SERVICE BULLETIN

Subject: Potential Leak - Drain Pump models - Brilliance Cuber/Nugget and CU50

Affected units: SCCP30, SCCP50, SCN60P, and CU50P with serial numbers 20071320011372 through 20101320012846. These units were produced and shipped in July 2020 through October 2020.

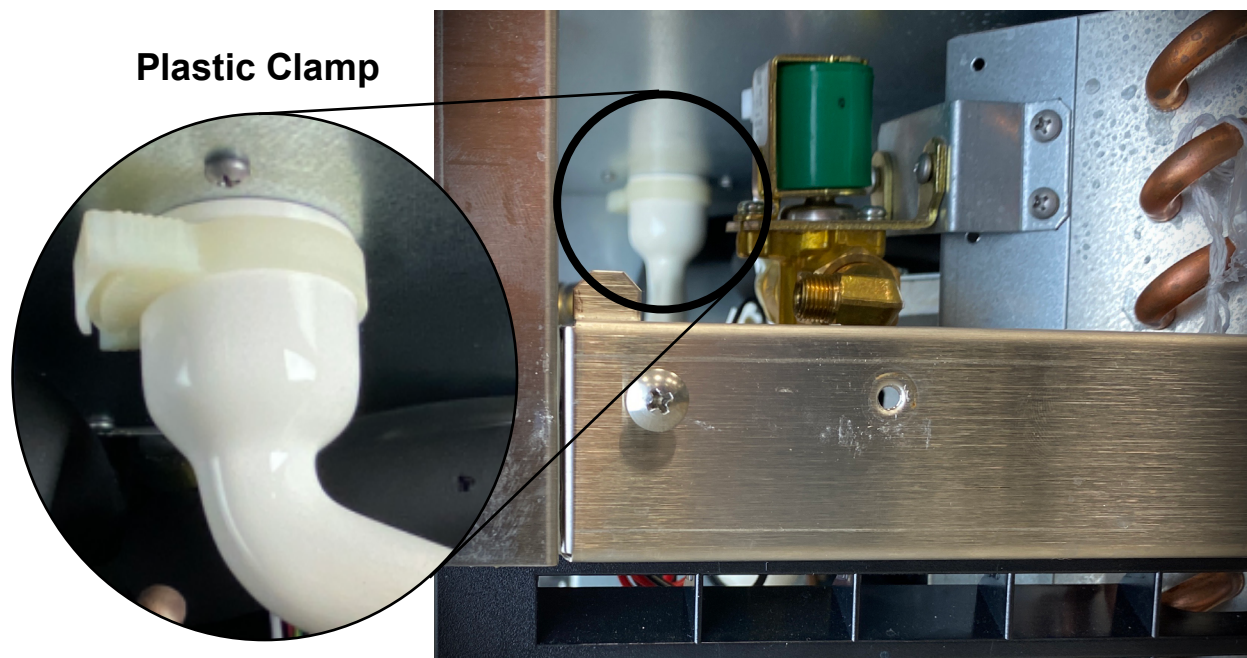
Affected units use a metal worm clamp on the bin drain connection. This clamp may allow water to drip out of the drain tube.

A visual inspection can be performed from the front of the unit. Remove the phillips screw located in the center of the black handle and then remove the front access panel. With the panel removed, look to the back of the unit for the bin drain connection and identify if the unit uses a metal clamp or a plastic clamp.

If the unit has a **plastic clamp, no further action is required**. If the unit is found to have a **metal clamp, the clamp should be replaced** with the correct Scotsman plastic clamp, part number 02-2814-13, which will be covered under warranty.
